**PLAN COMMISSION
MEETING NOTICE AND AGENDA
Thursday, April 16, 2026
6:00 PM
REVISED**

REPORT TO THE PLAN COMMISSION

Project Name: ICAP Development Site & Building Plan Review

SHEET
C1.1

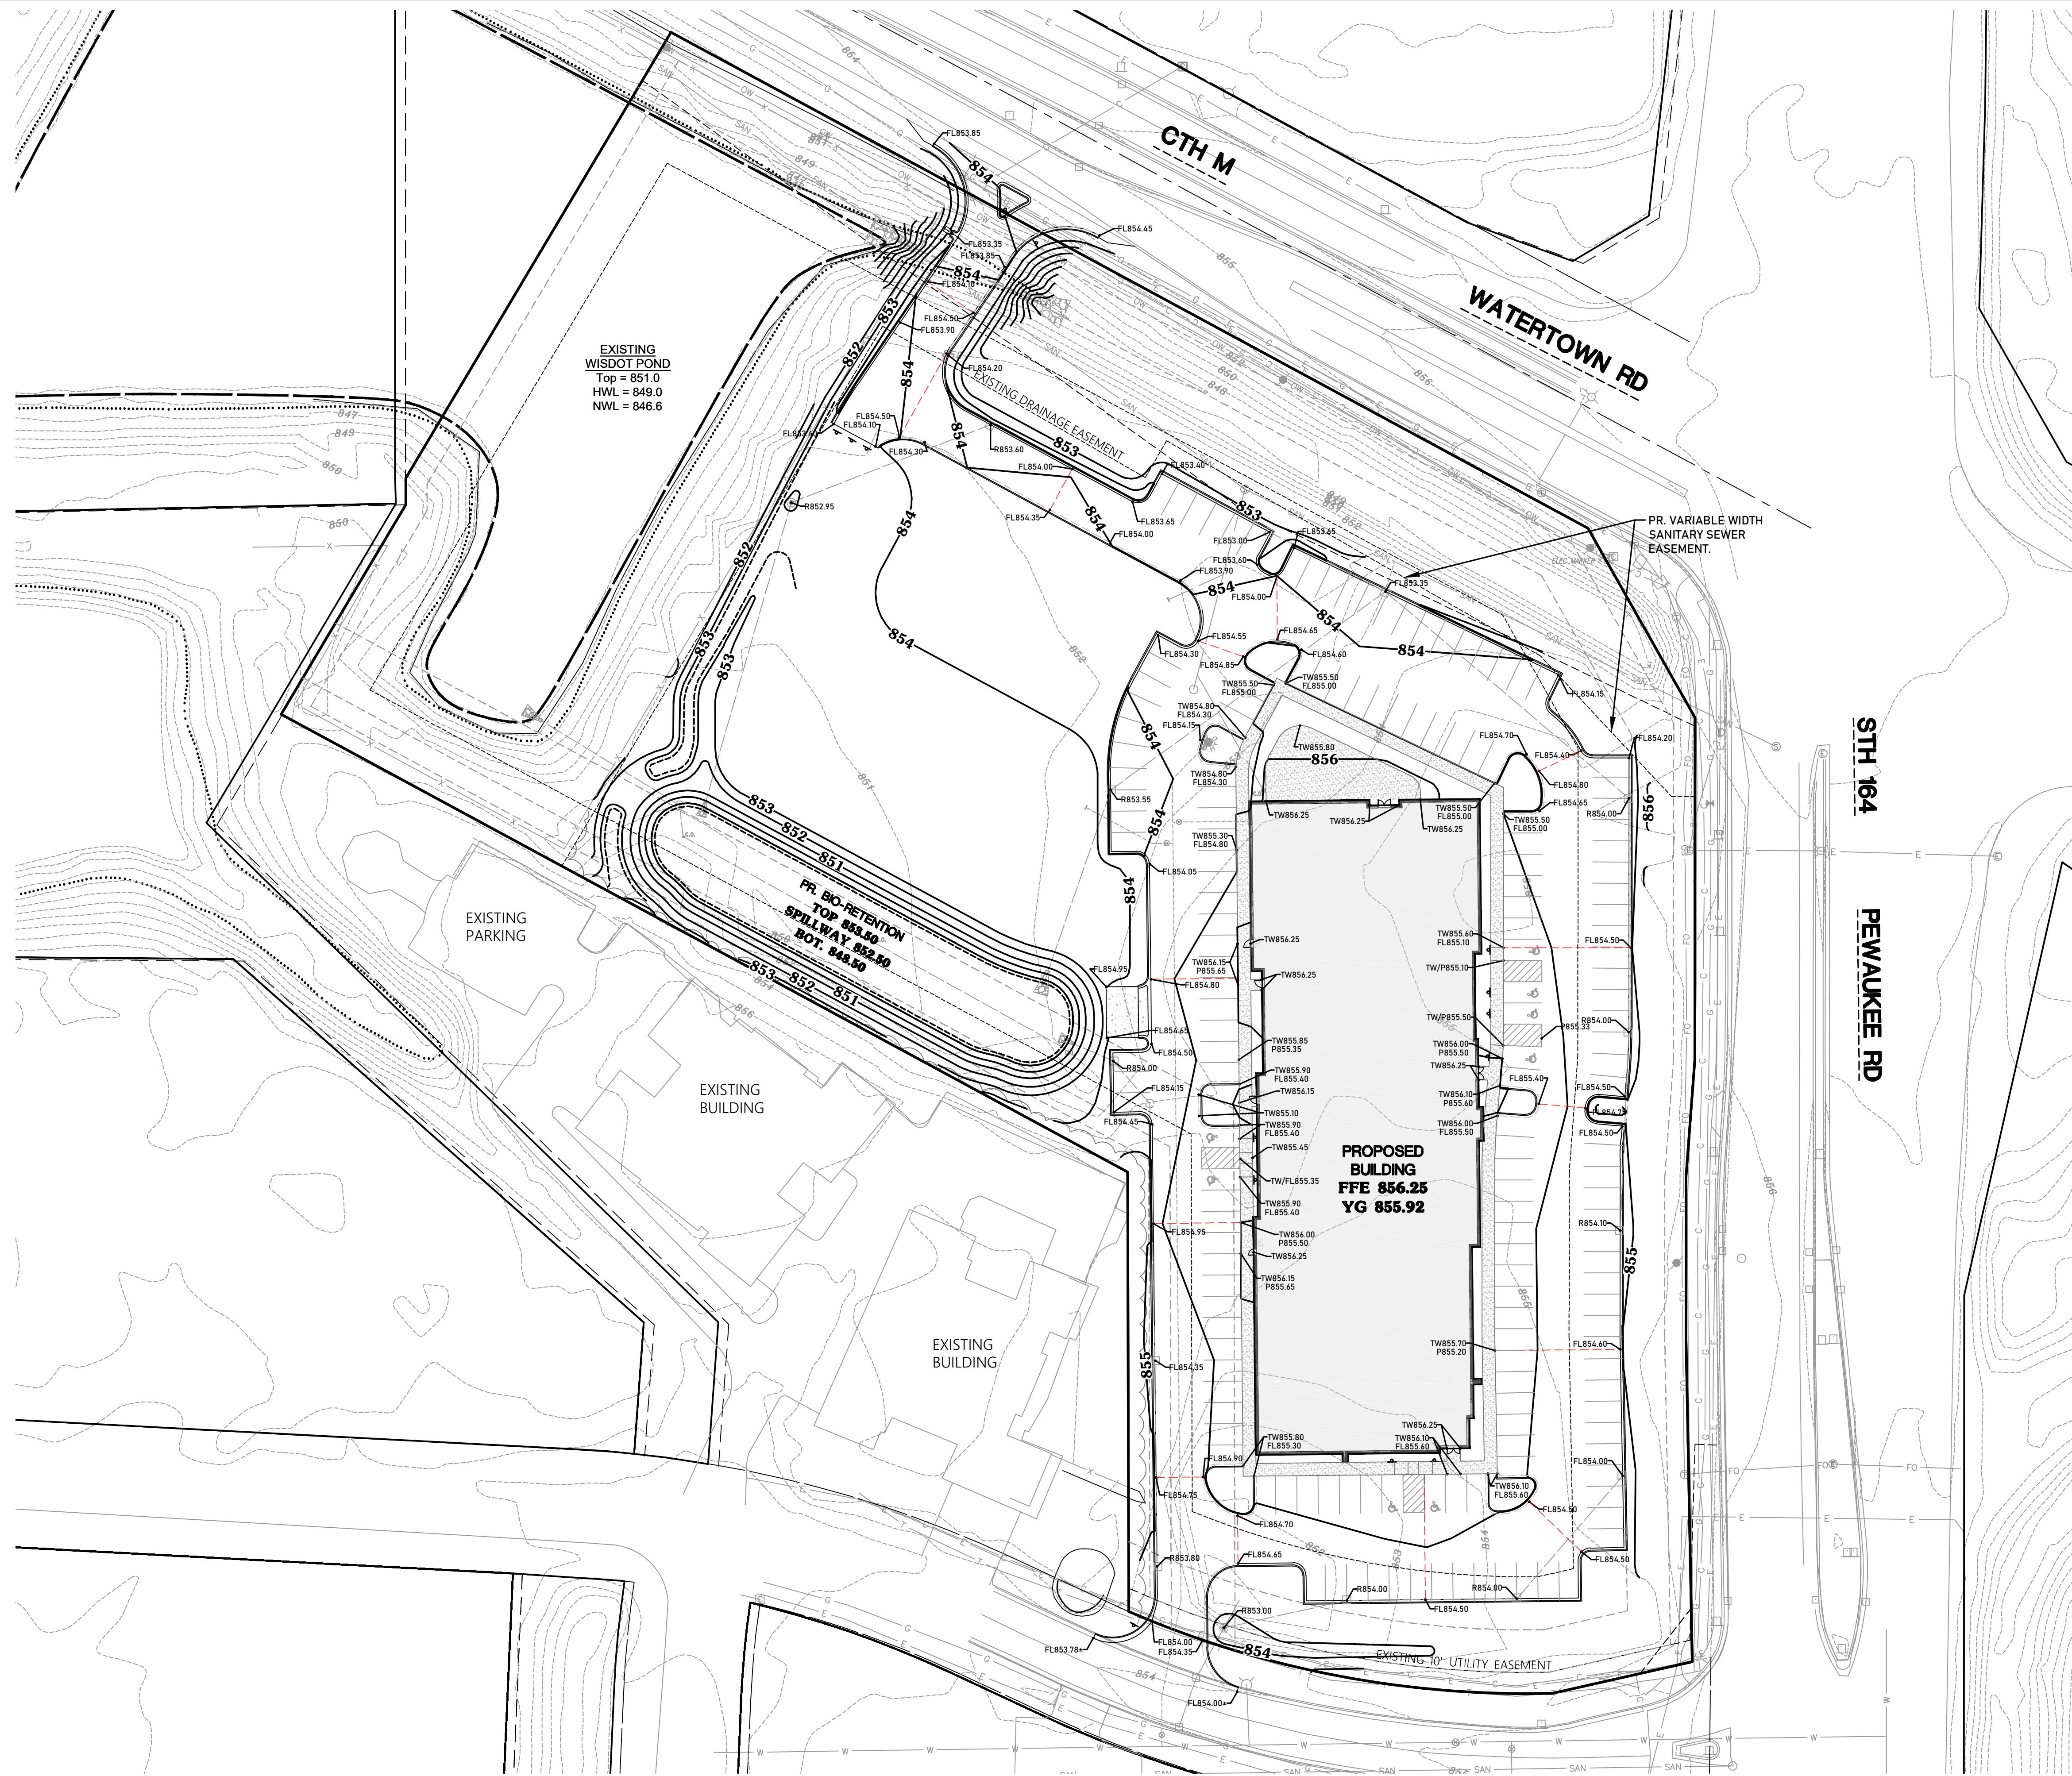
1. Please dimension a typical parking space size on the site plan in addition to the note stating a minimum size of 180 square feet. **Updated on Sheet C1.1**

2. In the Site Data Table on Sheet C1.1, please separate and list the greenspace proposed for both Phase 1 and Phase 2 of the development as well as the total. **Updated on Sheet C1.1**

3. The B-6 District requires a minimum paving setback of 10 feet from all property boundaries. The district also requires a minimum 30-foot parking and loading setback from all street rights-of-way. Please illustrate these setbacks on the site plan and eliminate any encroachments. **Updated on Sheet C1.1**

12. [Section 340-8.1B](#). requires that off-street parking be no closer than 50 feet to a residential district lot line unless completely screened from view, in which case the distance may be reduced to 20 feet. I do not see a dimension on the site plan; however, please revise as may be necessary. **Trio added dimensions to site plan on Sheet C1.1**
